Design, Safety, Schedule, and Cost Assessment of Parsons/Honeywell WHEAT Total Solution

Final Technical Report

**Prepared for:
Program Manager for Assembled
Chemical Weapons Assessment
(PMACWA)
APG, Maryland**

8 June 2001

Figure 5-3: Organic Removal Efficiency in Biotreatment Versus Ton Container Heel/Total Agent

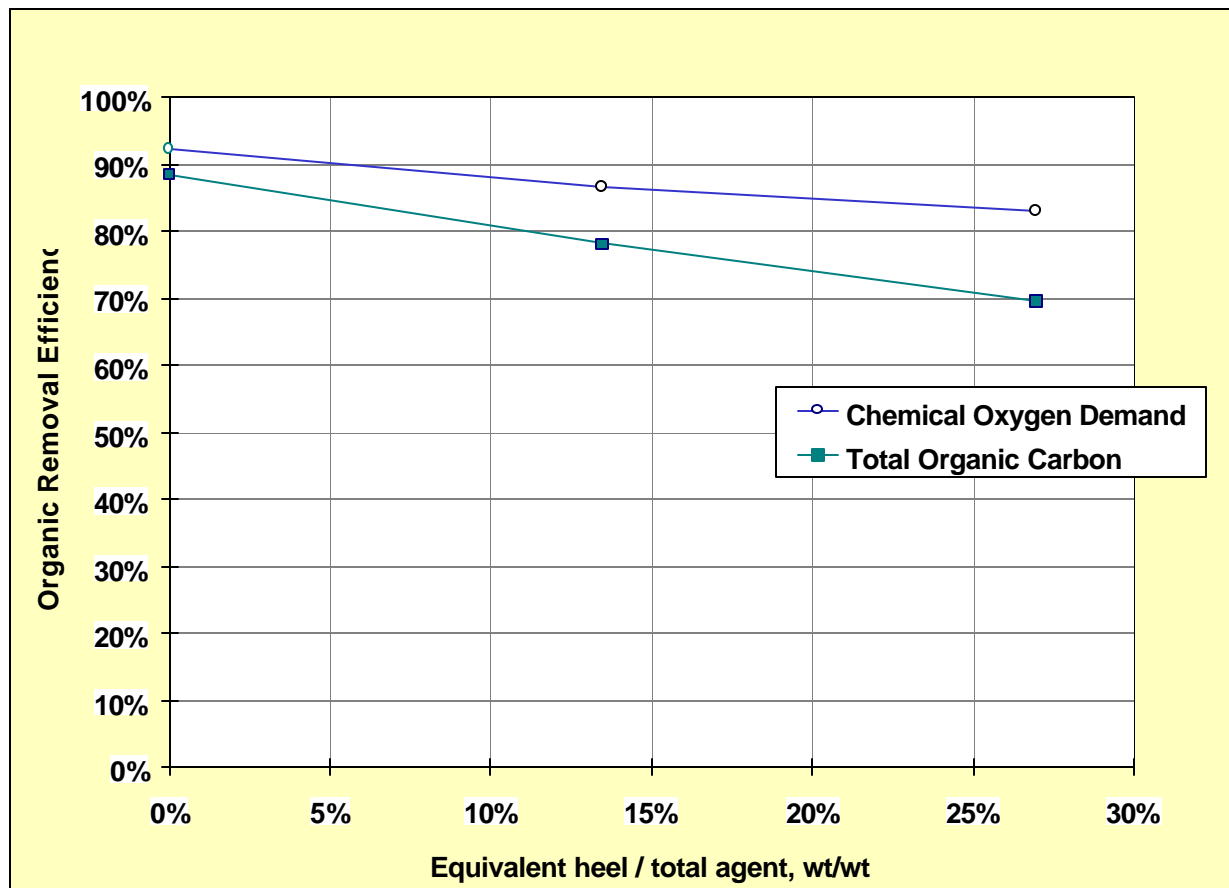
The WHEAT design assumes that at least 60 percent of the agent within a given round will be drainable. That leaves a heel quantity of up to 40 percent. In light of the test results illustrated in Figure 5-3, biological treatment of the combined heel and drained agent hydrolysate at Pueblo could be problematic. Without analytical and quantifiable data on the heel material however, the performance of a biological system treating this stream cannot be predicted.
